Re: Amendment of Prior Approval of Development Plans and Architectural Standards for the Straits Farm subdivision, New Albany County Club Section 27, located on the west side of State Route 605 directly south of Maplewood Cemetery

This letter is to memorialize recent communications between us concerning certain architectural details for the Straits Farm subdivision. The New Albany Company previously reviewed and approved development plans and architectural standards for the subdivision pursuant to a letter dated July 15, 2013 (the "Approval Letter"). This letter is intended to amend the Approval Letter consistent with some revisions that we have recently agreed upon. These amendments are as follows:

Re: Approval of Development Plans and Architectural Standards for the Straits Farm subdivision, New Albany Country Club Section 27, located on the west side of 605 directly south of Maplewood Cemetery.

The New Albany Company has reviewed and conditionally approved the Development Plans and Architectural Standards for the Straits Farm subdivision, New Albany Country Club Section 27, as stated in Section 6 (b) of the Lot Sale and Purchase Agreement between The New Albany Company LLC, a

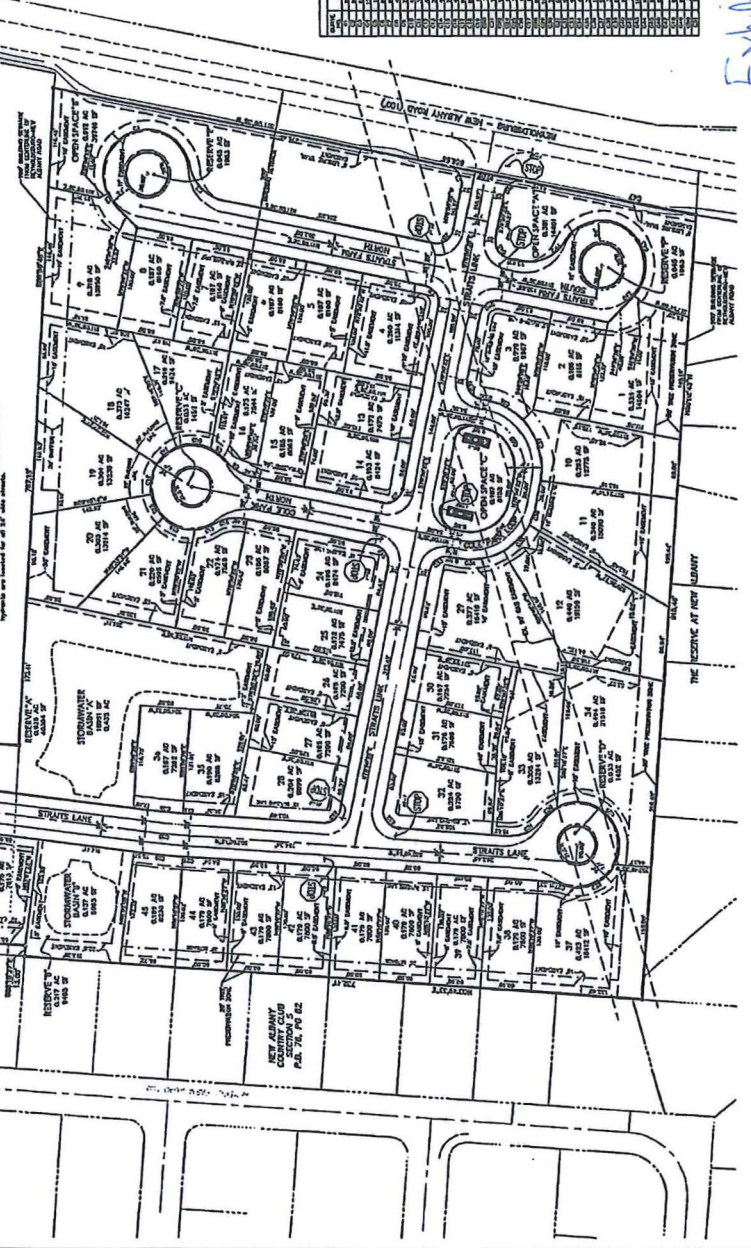
The Site Plan prepared by Advanced Civil Design and labeled Final Development Plan for New Albany Country Club Section 27, Site Plan, dated 5/1/2013, attached hereto and labeled Exhibit SP-1 is approved.

Houses built on lots 1, 2, 3, 4, 5, 6, 7, 8, 9, 14, 24, 28, 32, 41 and 42 shall be brick, as illustrated on attached Exhibit SP-2. The brick construction is limited to all elevations of the main building mass of each house, except that brick shall be required on the garage for House Plan A, and within the pediment on House Plan B if the two story elevation is constructed.

"Homes built on lots 1, 2, 3, 4, 5, 6, 7, 8, 9, 24, 28, 29, 36, 41 and 51 shall be brick, as illustrated on attached Exhibit SP-2. The brick construction is limited to all elevations of the main building mass of each house, except that brick shall be required on the garage for House Plan A, and within the pediment of House Plan B if the two story elevation is constructed."

2. All references to Exhibit SP-2 in the Approval Letter shall be deemed to refer to the document attached hereto that is labeled "Revised Exhibit SP-2".
3. The second paragraph of Item II in the Approval Letter is hereby deleted in its entirety and shall be replaced with the following:

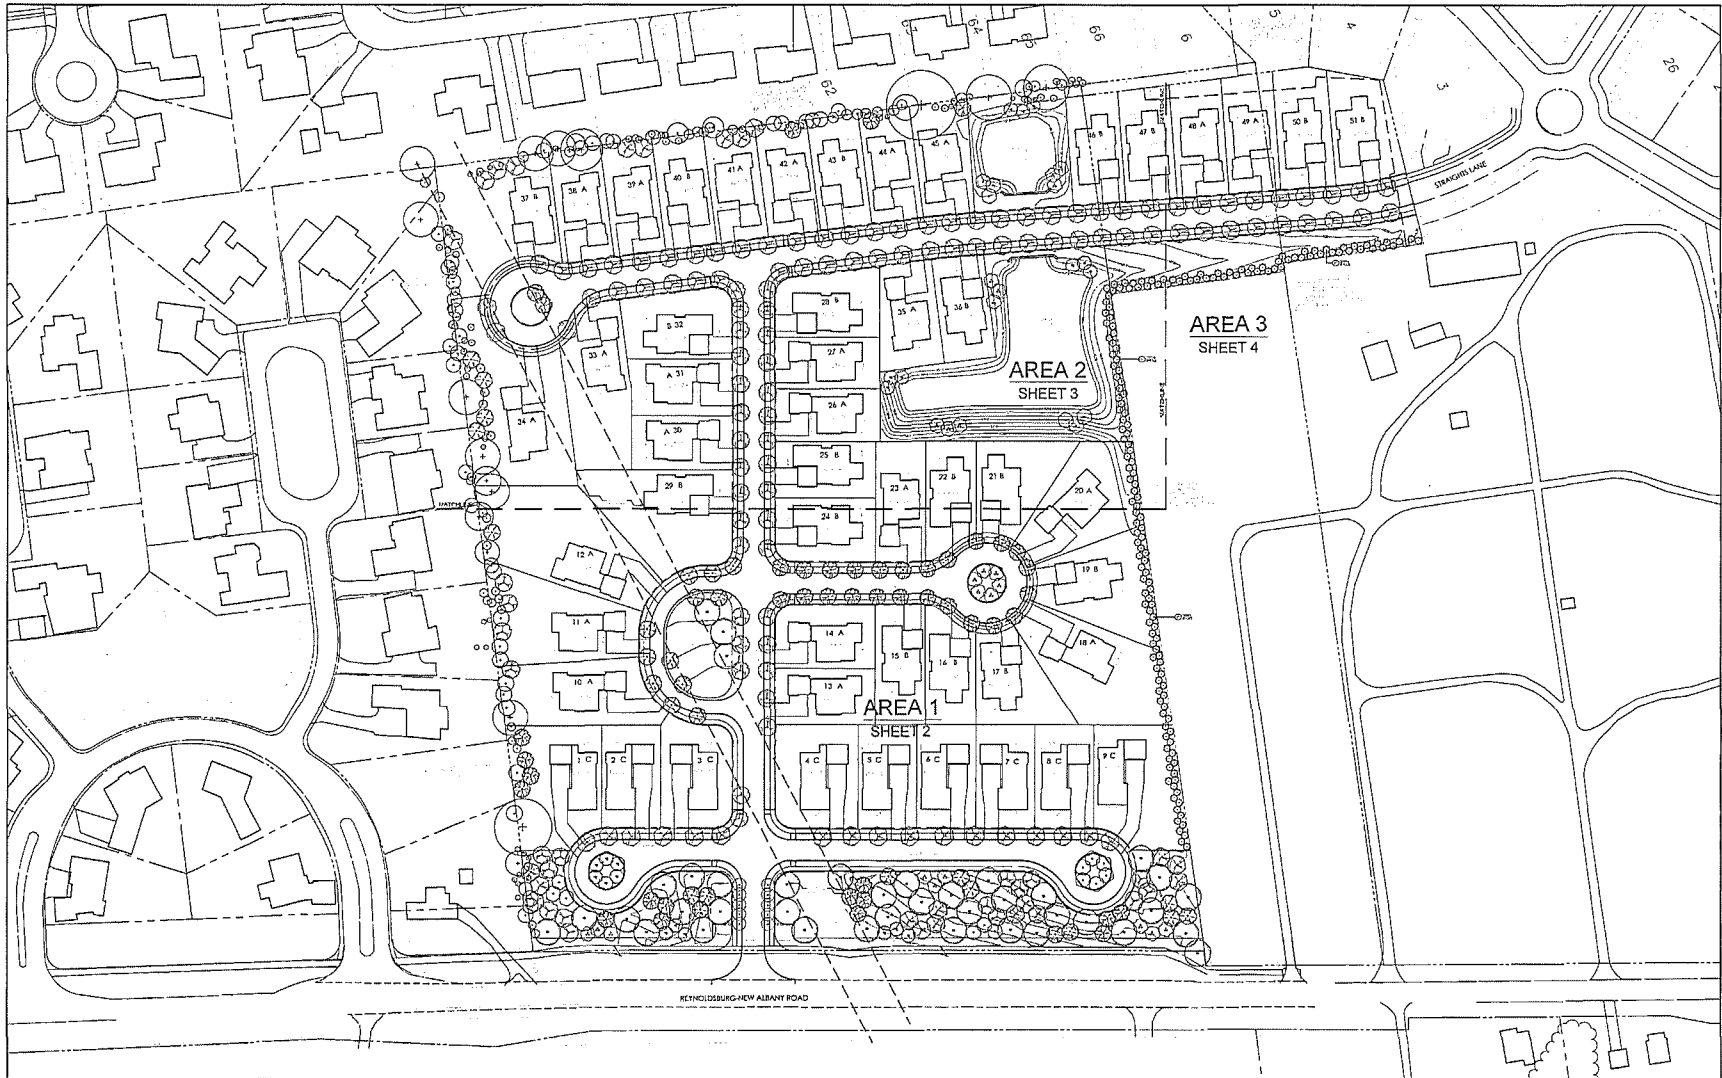
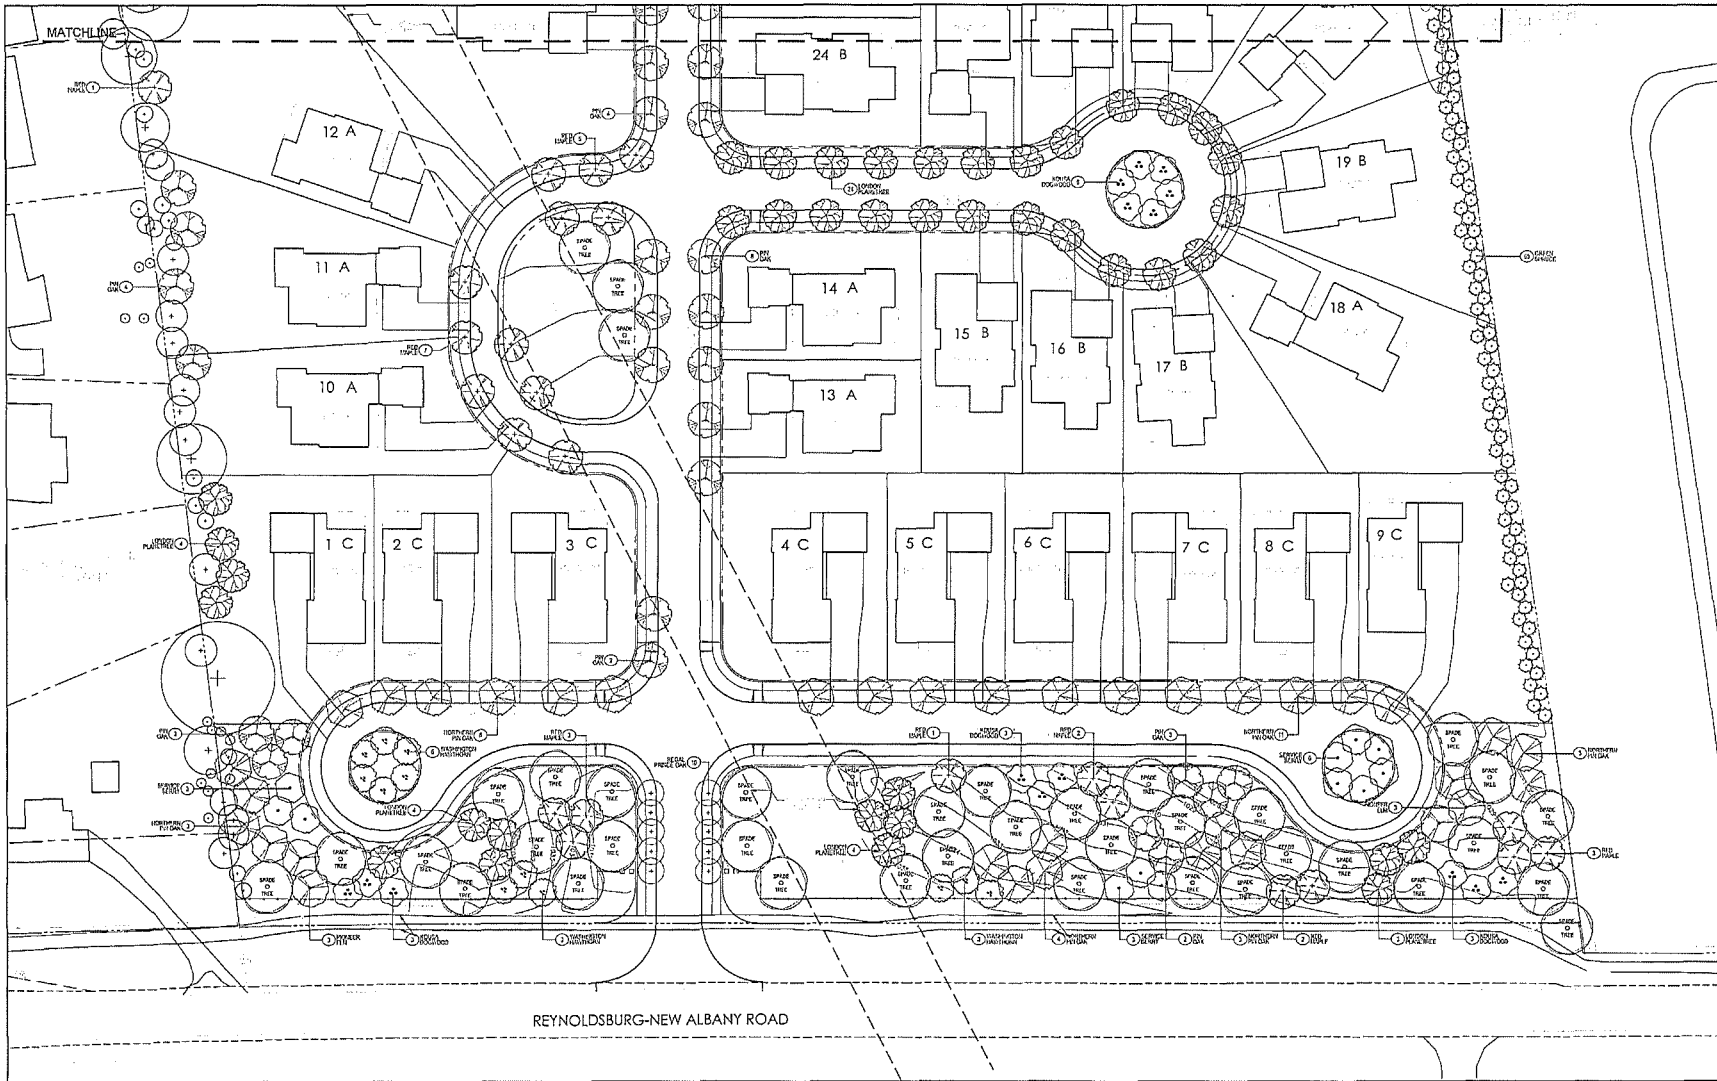
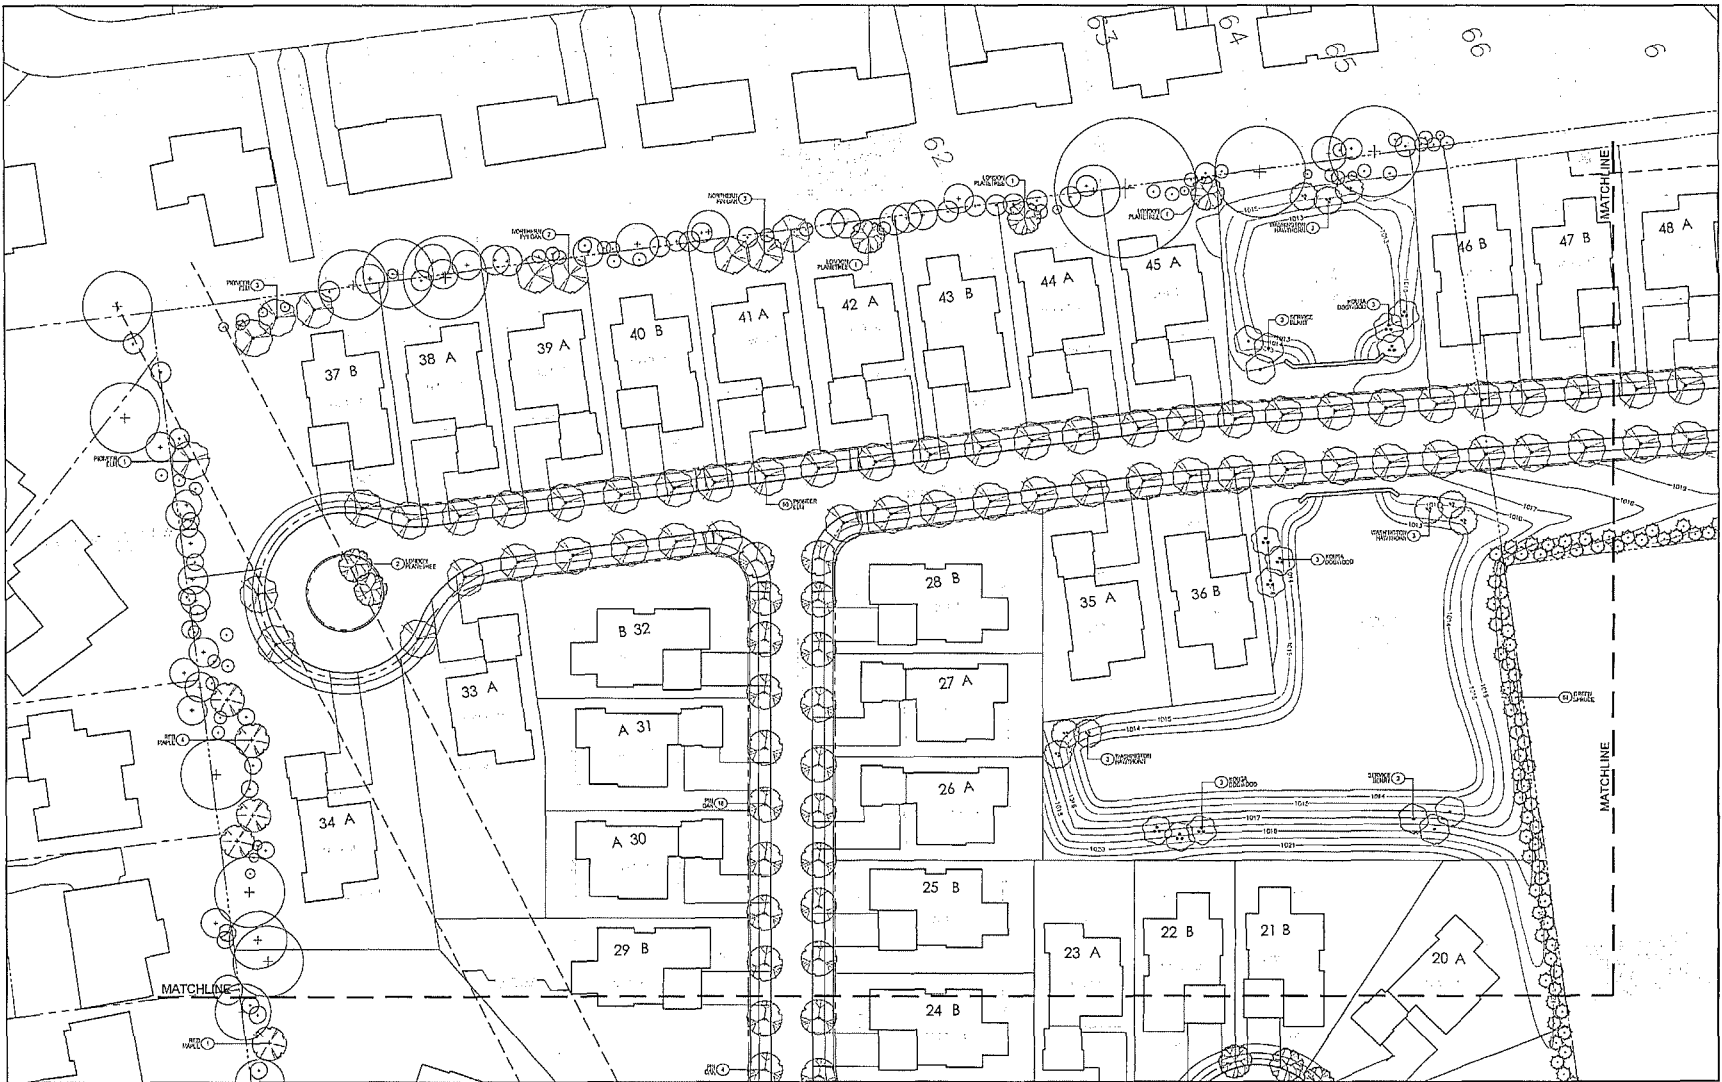
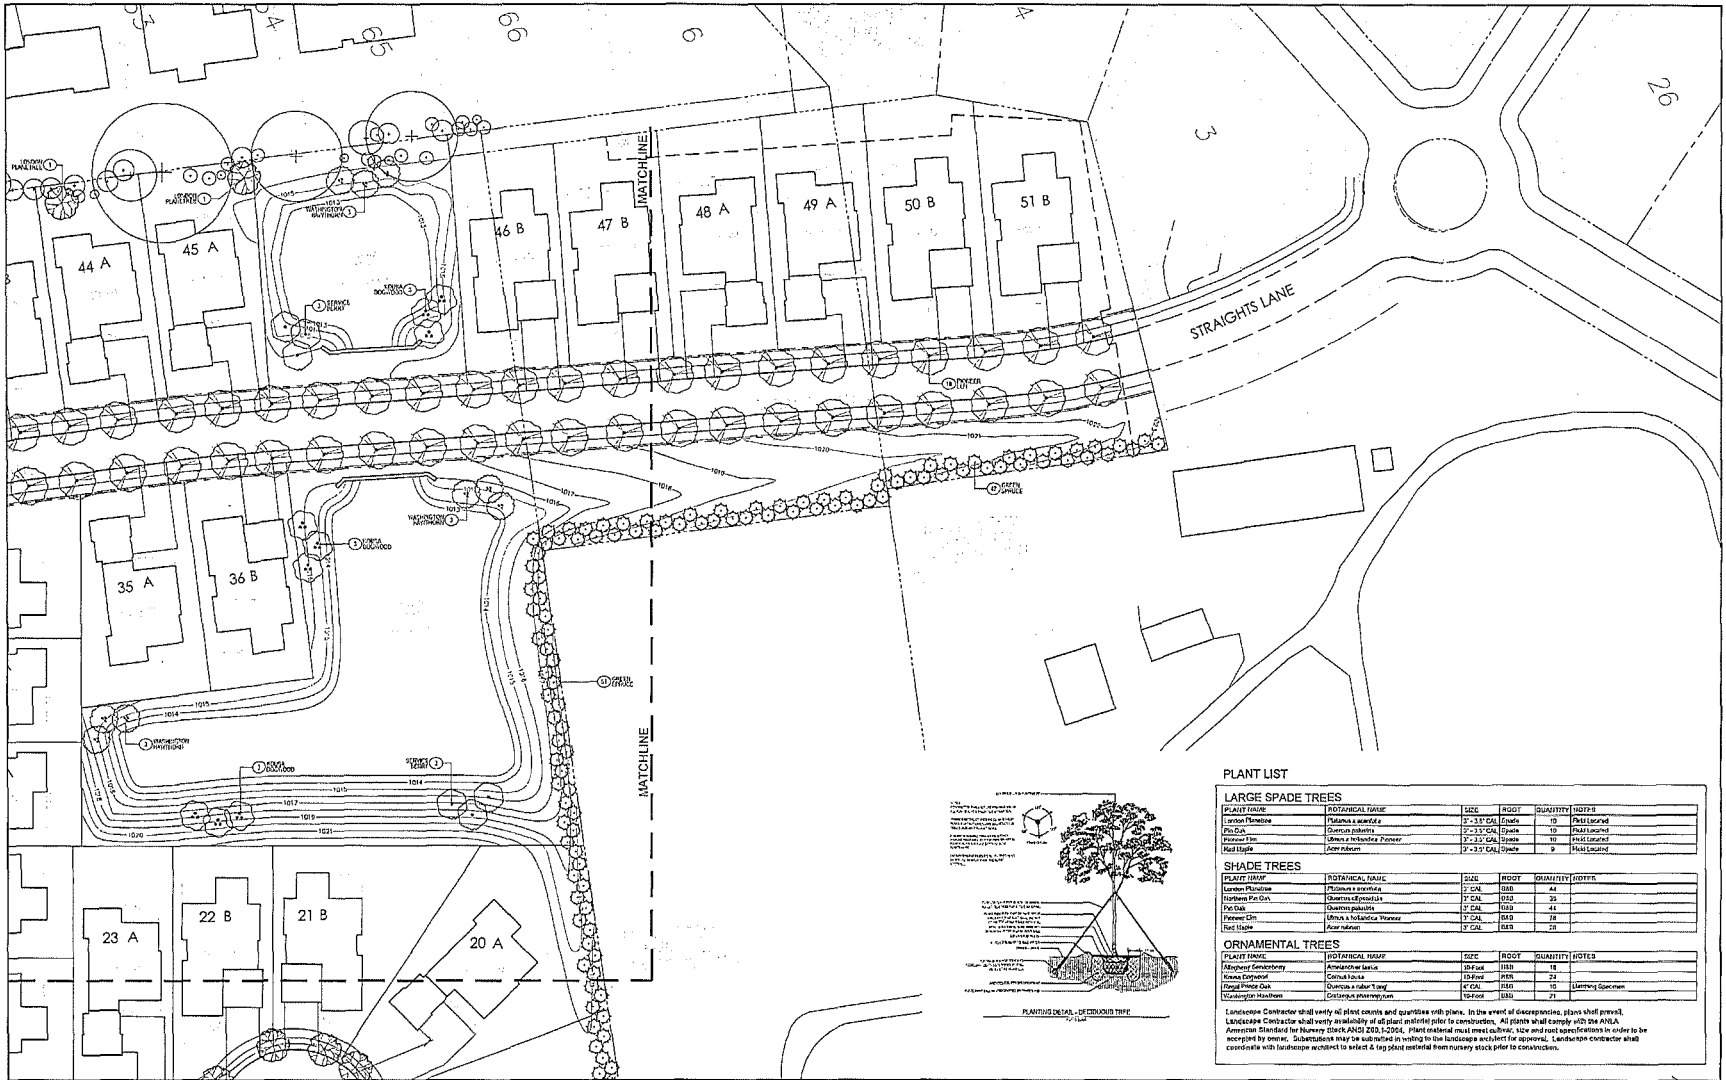
The Landscape Plan labeled The New Albany Company MI-605 Landscape Plan, dated May 29, 2013, attached hereto and labeled Exhibit L-1 thru L-4 is approved as submitted with one modification. The dense evergreen planting shown along the perimeter of Maplewood Cemetery shall be modified to include 4 board horse fence, mounding approximately 3 feet in height and plantings of large deciduous and ornamental trees. Final planting plan adjacent to the cemetery shall be agreed to by both parties prior to installation.
